# Design Note

## 101 Albert Street - Foundation and Retention System Changes

**Project Name:** 101 Albert Street

**Document No:** ALB-RBG-DNT-ST-00-000-01

Figure 1 - Proposed Bulk Excavation Diagram

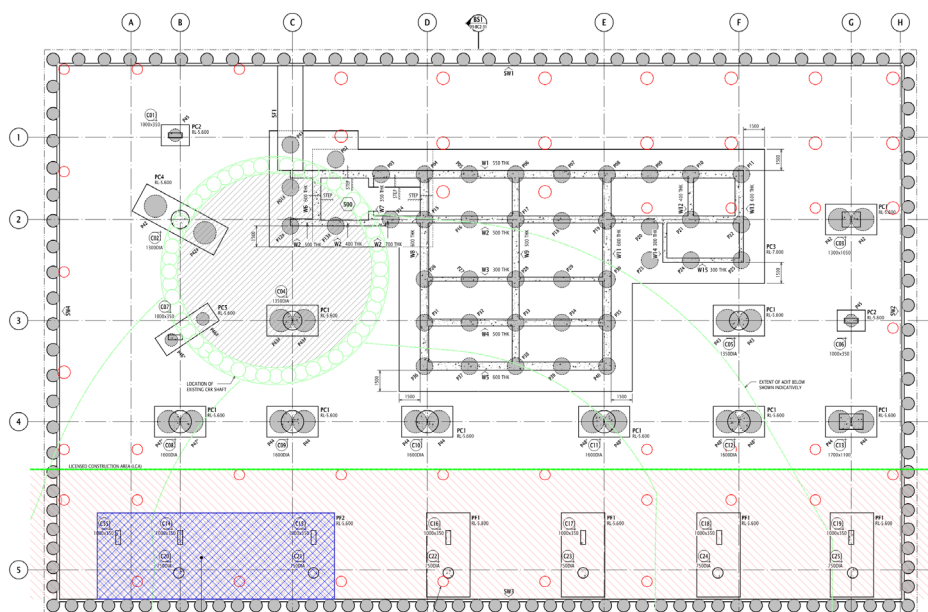
- i. The current Geotechnical advice which informs the structural design is based on a desktop study. Project specific Geotechnical investigations will be undertaken once the site is accessible. This existing geotechnical borehole information indicates a local zone of weaker material to the Albert Street, north-west corner, within the RL-8m maximum continuous excavation zone (denoted by red hatch in Figure 1), where the extremely weathered rock drops away. There is a risk that the founding material in this area (denoted by blue hatch in Figure 1) is residual soil which would impact retention system piles and column foundations in the area.

Due to the potential for weaker material, ground improvement works may be necessary within the LCA (i.e below RL-8m). These works would be restricted to the base of some of the pad footings and would involve controlled localised excavation, and replacement with N20 mass concrete. Where works are expected below the RL-8m maximum continuous excavation zone, it is proposed to be undertaken in stages with a maximum excavation depth of 2m and 3m<sup>2</sup> area.

Similarly, due to the potential weaker material, it is necessary to extend the retention system piles along this frontage below the RL-8m to RL-10m.

Figure 2 - Proposed Detail to Break Down Existing Piles

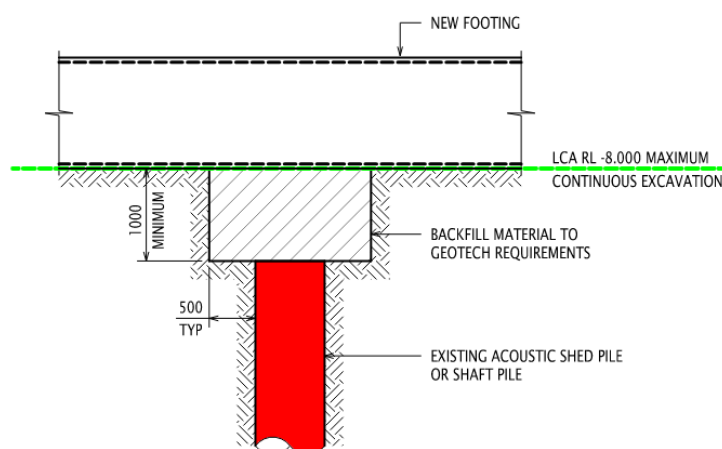
- ii. There are existing acoustic shed piles across the site that are currently documented to remain. These extend from current ground level to below the future basement depth and terminate in medium to high strength rock. Some of these piles terminate in close proximity to the CRR Cavern. Due to this, there is a risk that these piles could act as stiff points and be loaded by the future foundations.

To mitigate this risk, it is proposed to remove of the tops of the piles below RL-8m to remove possible interaction with future foundations. The pile and surrounding materials will be replaced with an engineered backfill material to be confirmed by the Geotechnical Engineer.
